PLANNING PROPOSAL FORM

RE: RFI Delays and Meeting Summary - TG Millner Planning Proposal

**Planning Proposal PP2024/0001 – 146-150 Vimiera Road, Marsfield
Response to Preliminary Council Feedback**

| Meeting Subject: | Feedback from Council Officers on preliminary assessment of Planning Proposal | | |

Figure 6: Indicative distribution of dwelling typologies

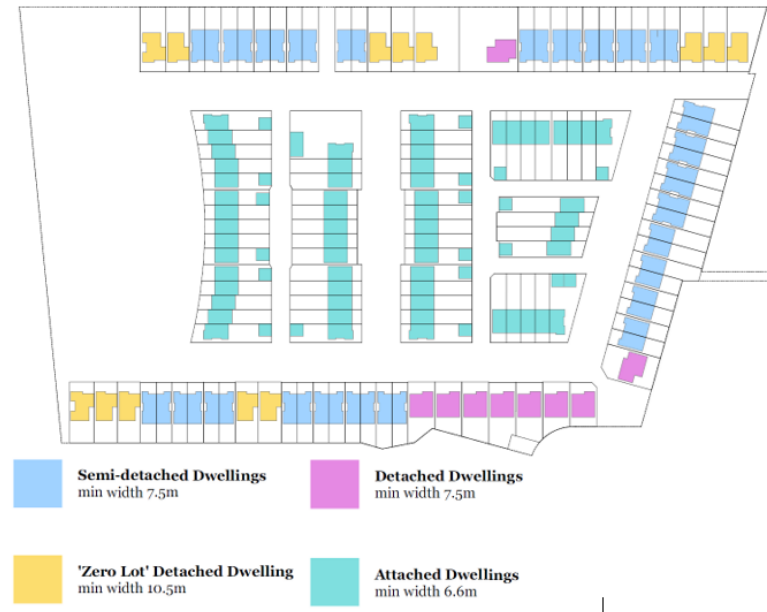
At this stage, it is Council's opinion that the inclusion of secondary dwellings on lots less than 450 sqm in the Planning Proposal is not supported.

We note that secondary dwellings were incorporated by the Applicant into the masterplan in direct response to Council's verbal and subsequent written pre-lodgement feedback of 31 March 2022 (see excerpt below) that the activation of laneways with such uses was desirable. We ask that Council reviews its previous advice and advise if it still holds this view, or if its position has changed and whether any other uses (home offices, guest bedrooms etc) are suitable for activation of the laneways. In any case, this is a matter best addressed through the refinement of the Draft DCP and does not require any alteration to the Planning Proposal.

In our meeting with Council, officers expressed concern that there was potential for continuous runs of secondary dwellings to create a two-storey 'wall' to rear laneways. We note that this outcome would not be allowed under the provisions for secondary dwellings set out in Sections 2.3.4 and 2.4 of the Draft DCP. This concern could be further addressed by the inclusion of additional DCP provisions (subject to Council feedback on the Draft DCP), such as by reference to Figure 6 in the Draft DCP which shows less than 1/3 of attached dwellings as having laneway-facing secondary dwellings.

If Council is opposed to the provision of secondary dwellings towards the laneway, then this is best addressed through clear controls contained through the refinement of the Draft DCP. There is no alteration required to the Planning Proposal in order to achieve this.

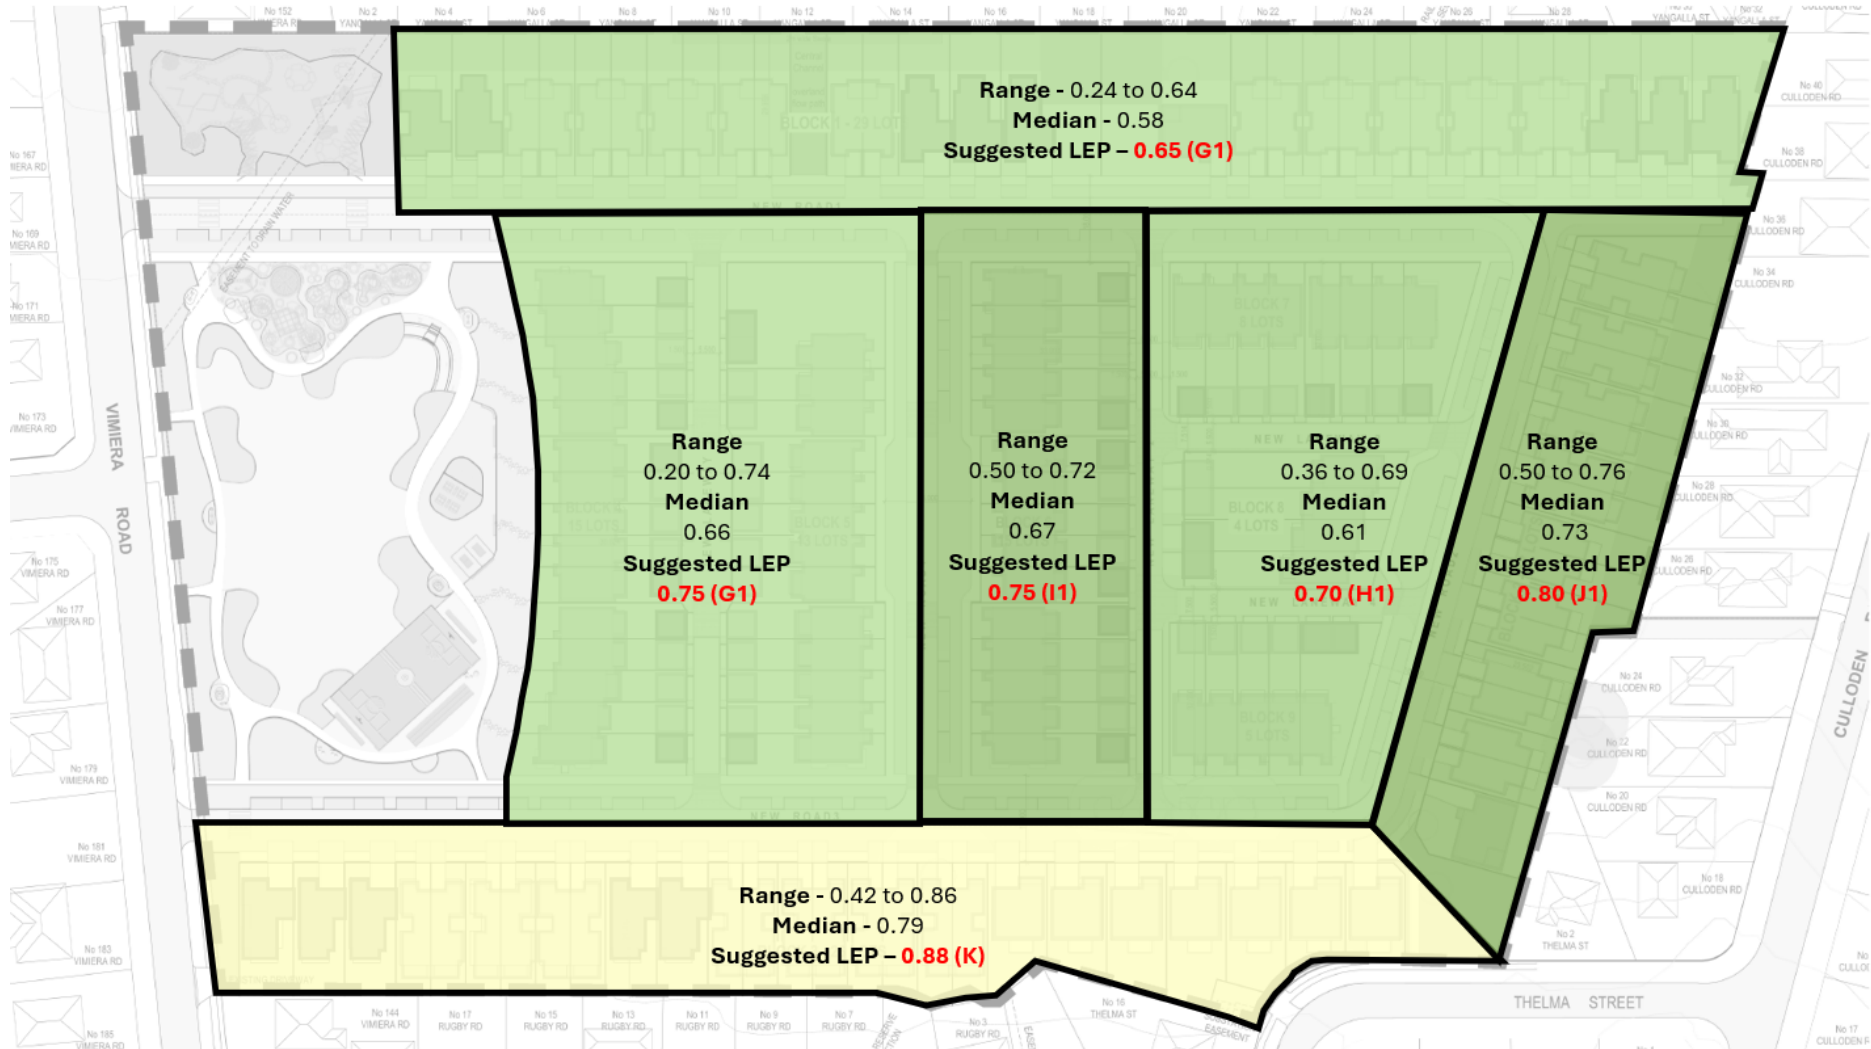
Furthermore, the application has not provided details in relation to the street networks capacity to demonstrate compliant swept paths of a heavy rigid waste collection vehicle (AS2890.02). The properties proposed to be located on in the eastern corner are of particular concern (please see below as outlined in pink). Please demonstrate the developments' ability to comply with heavy rigid waste collection vehicle swept paths. Council does not agree that this can be dealt with as part of a site-specific DCP as waste collection is an essential service and the ability to provide waste services to dwellings may impact dwelling yields/densities and supporting LEP controls.

Proponent's Response

a road is considered to be unnecessary to resolve the public/private interface and places unnecessary emphasis on cars and road dominance within urban design.

Figure 1 - 20% AEP Flood Depth and Elevation

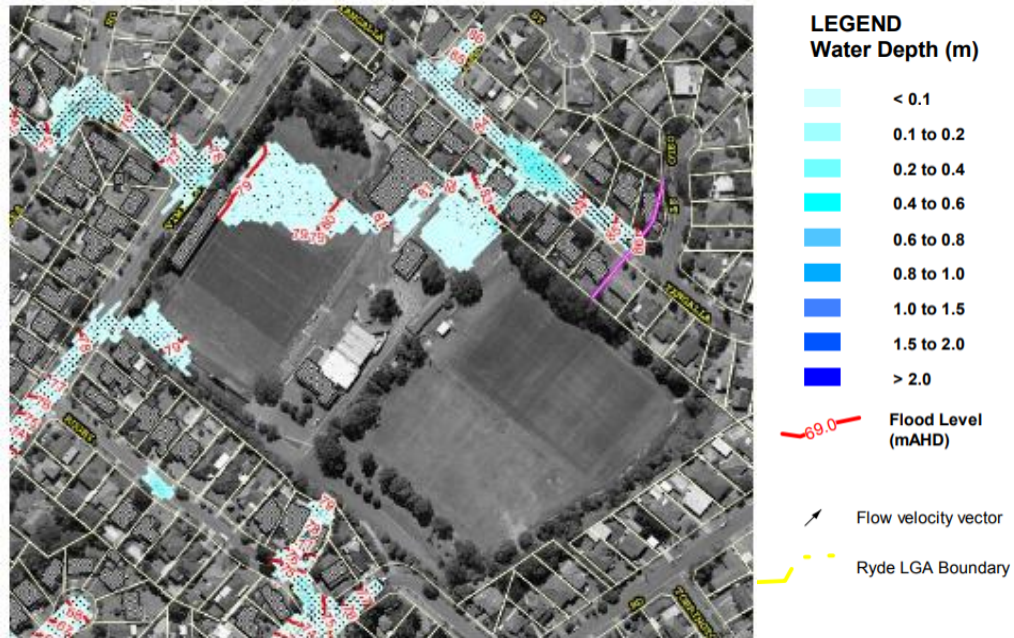
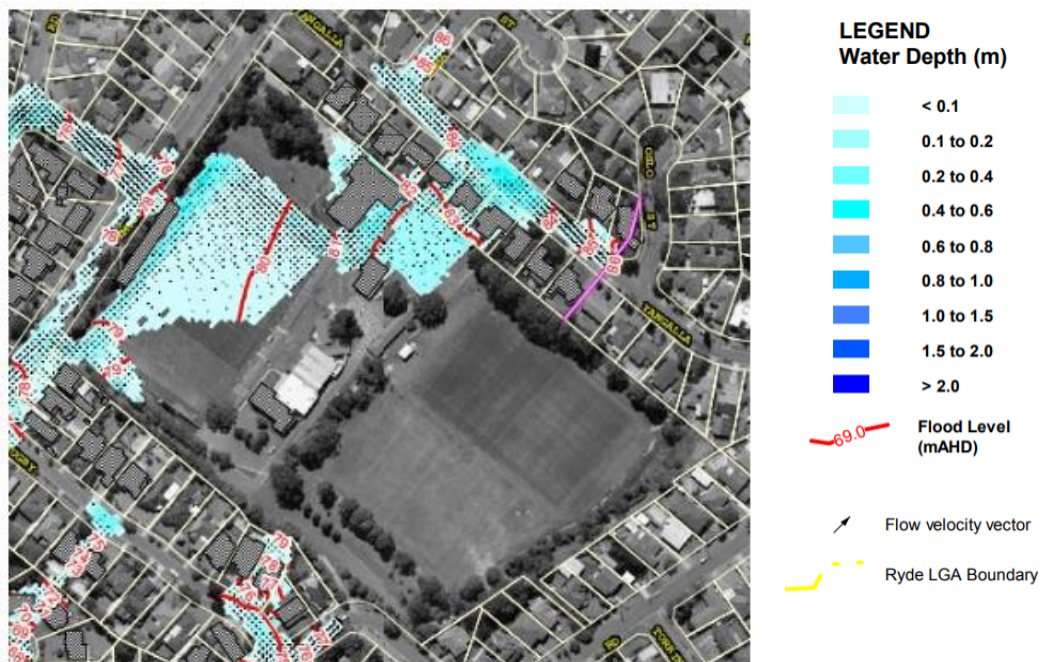
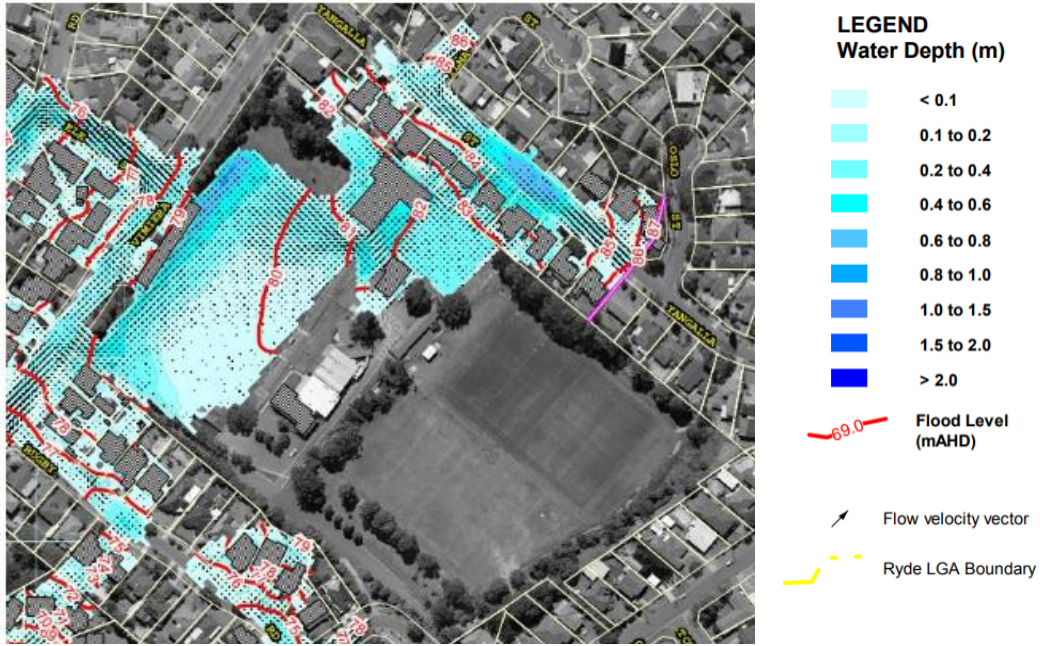
The portion of the site fronting Vimiera Road is affected by PMF and 20% AEP flood events. The proposal has been supported by a Stormwater Servicing Report produced by Northrop, dated 10/05/2022, which in summary notes that the proposal takes advantage of the site layout to implement flooding and Water Sensitive Design Solutions. It is noted this is the same report that was submitted with the 2022 Planning Proposal.

As the report does not provide pre- or post-development scenarios, it is unclear if the proposed R2 rezoning to the northwest will be located in flood prone land. Additionally, an assessment has not been provided on how the proposal is consistent with most recent flood planning considerations. The flooding across the western portion of the site also presents as a risk to resident egress and emergency access. Alternative access and egress arrangement may be required to demonstrate R2 viability. Council does not agree that this is a matter to be dealt with at DA stage. An updated report is required to demonstrate consistency with the Ministerial Direction 4.1 Flooding.

Northrop is reviewing Council's preliminary feedback and will prepare a response to these matters on behalf of the Applicant. It is intended that we would await Council's formal written feedback to ensure that this advice addresses all matters relating to flooding and stormwater requested by Council.

The Stormwater and Flooding Assessment prepared by Northrop and submitted with the Planning Proposal demonstrated a practical stormwater management strategy for the small area of mapped overland flow flooding to contain and divert these floodwaters away from proposed residential lots and into a channel/pipe system towards an on site detention (OSD) tank. This approach is capable of ensuring that land which is proposed to be rezoned to residential will not be flood affected. Based on the flood information already provided, this is not contentious and reflects a standard mitigation measure to overland flow flooding, which as noted in Northrop's prior report is a result of inadequate Council stormwater infrastructure within Yangalla Street.

The Section 9.1(2) Local Planning Direction allows a Planning Proposal to be inconsistent with the direction where the inconsistencies are of 'minor significance'. Given the limited area of the site which is subject to flooding, and the clear and readily achievable pathway to resolve any residual flooding risks, it is considered that the inconsistency for this Planning Proposal certainly meets the 'minor significance' test. Notwithstanding that a formal response will be prepared by Northrop following Council's formal written feedback, this could equally be provided following Gateway Determination and prior to public exhibition (or equally provided along with the first Development Application in respect of the site).

7. *Street Network and Waste Management*

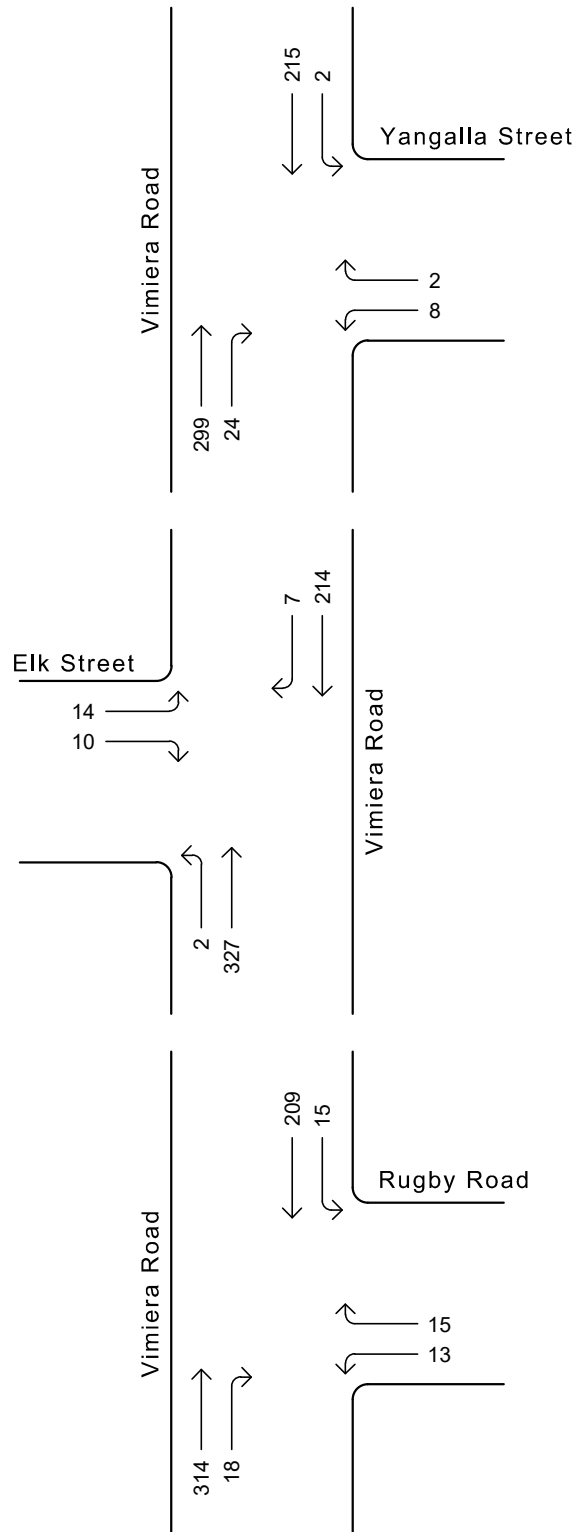
Furthermore, the application has not provided details in relation to the street networks capacity to demonstrate compliant swept paths of a heavy rigid waste collection vehicle (AS2890.02). The properties proposed to be located on in the eastern corner are of particular concern (please see below as outlined in pink). Please demonstrate the developments' ability to comply with heavy rigid waste collection vehicle swept paths. Council does not agree that this can be dealt with as part of a site-specific DCP as waste collection is an essential service and the ability to provide waste services to dwellings may impact dwelling yields/densities and supporting DCP controls.

19. Roads within the development will be provided in accordance with DCP 2014, including 18 metre reserves, 4.5 metre verges and nine metre carriageways. These dimensions will cater for waste collection vehicles. Laneways will be provided with 5.5 metre carriageways and variable verge widths.
20. With regards to the area identified by the council in the north-eastern corner of the site (where the road is a dead end serving a small number of dwellings – some four houses), a design solution will be able to be achieved for these dwellings at the development application stage. For example, bins from these dwellings could be located on Road 1 or Road 2 for collection.
21. We trust the above provides the information you require. Finally, if you should have any queries, please do not hesitate to contact us.
